SERVICE INFORMATION

LAND-ROVER PETROL AND DIESEL MODELS

Vol. 1 No. 11

January, 1973

Fig. 1 Impulse tool kit 530101A

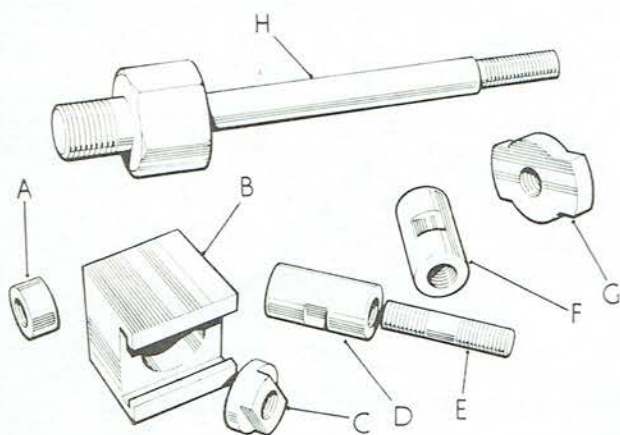
MODIFICATION: Introduction of an adaptor kit to suit impulse tool 18G284, to aid commonisation. The kit also provides all the adaptors previously included with impulse tool 530101.

REMARKS: When stocks of the earlier impulse tool and adaptor kit 530101 are exhausted only the above listed tool kit 530101A will be stocked. The kit is for use with the current impulse tool 18G284 which, if not held, must be ordered separately.

Distributors and Dealers are requested to mark up their Series II and IIA Service Literature in accordance with the above information. The Series III Repair Operation Manual will be revised accordingly at the next available revision.

Fig. 2 Torque spanner adaptor RO 1013 for mainshaft nut spanner

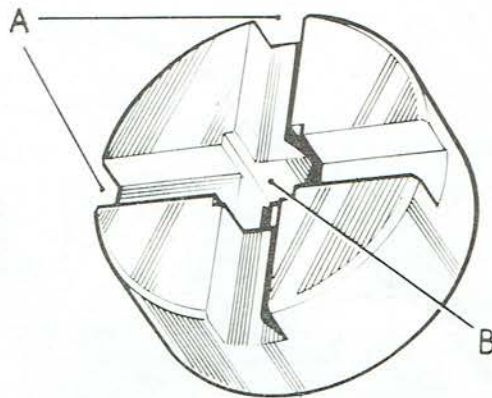
MODIFICATION: Introduction of a torque spanner adaptor for use with the existing box spanner, Part No. 600300, for the gearbox mainshaft nut.

REMARKS: The current gearbox build specification requires the special nut Part No. 217477 at the transfer gear end of the gearbox mainshaft to be tightened to 12,5 kgf.m (90 lbf.ft.) prior to turning up the lockwasher. The above listed adaptor is now available for this purpose and is designed to fit on the end of the existing mainshaft nut spanner Part No. 600300. It is recommended that this torque loading be applied on earlier, as well as later, gearboxes during the applicable overhaul procedure.
